Contract #: 04-0120F4Cty: SF/ALA Rte: 80 PM: 13.2/13.9File #: 69.25B**QUALITY ASSURANCE -- NON-CONFORMANCE REPORT****Location:** Changxing Island, Shanghai, P.R. China**Report No:** NCR-000541**Prime Contractor:** American Bridge/Fluor Enterprises, a JV**Date:** 18-Dec-2009**Submitting Contractor:** Zhenhua Port Machinery Company, Ltd (ZPMC), Changxing Island**NCR #:** ZPMC-0514**Type of problem:**

**Reference Description:** Missed UT Indication by QC, Segment 8BW**Description of Non-Conformance:**

**Job Name:** SAS Superstructure

**Subject:** NCR No. ZPMC-0514

WELD NUMBER: SEG045A-001

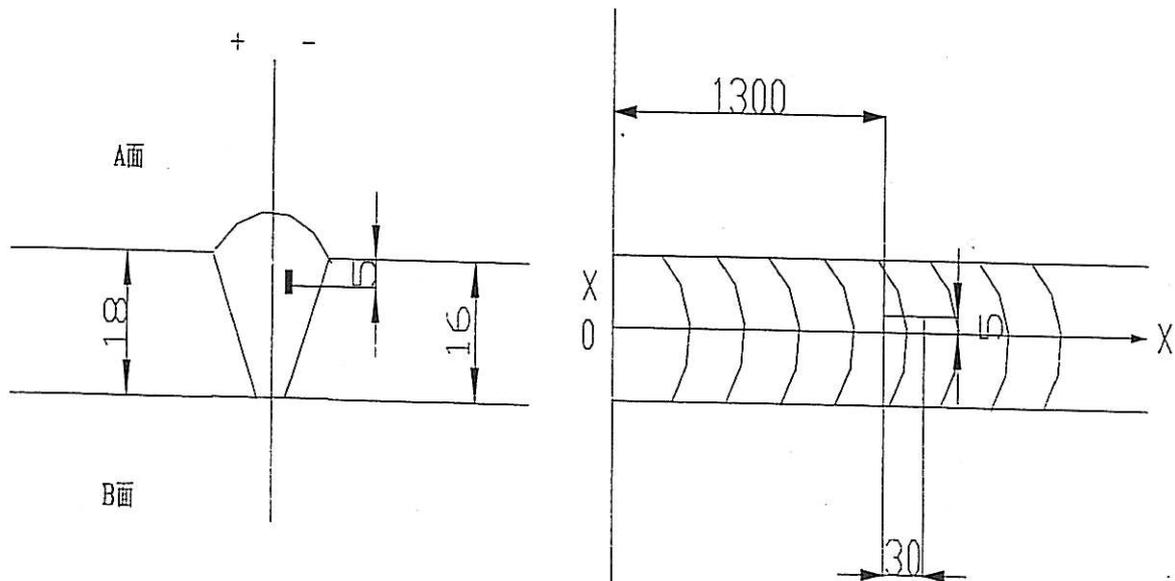
Rejected indication found by ultrasonic inspection is less than the maximum allowance aggregate length.

(UT探伤发现的缺陷总长度小于最大允许长度。) SEG045A-001

1. Did not clear the weld pass completely in time.

1. 从缺陷距离端面较近一侧 ( $D \leq 0.65T$ , D为缺陷深度, T为板厚) 采用碳刨或打磨的方法去除焊缝缺陷;
  2. 参照返修焊接工艺规程 (WPS) 准备正确的接头型式, 预热和焊接;
  3. 焊前对修补区域进行VT检测保证缺陷完全被清除;
  4. 将修补区域打磨到与母材或邻近焊缝平齐;
  5. 根据批准的车间图纸检查焊缝.
- 
1. Gouge or grind from nearer side from metal edge ( $D \leq 0.65T$ , "D" is depth of defects, "T" is thickness of metal) to remove all defects;
  2. Follow repair WPS for joint preparation, preheat, and weld deposit;
  3. Verify with VT no defects remain in the weld joint prior to welding;
  4. Grind the repaired area flush with base metal or the adjacent weld;
  5. Check the welds according to the working drawings.
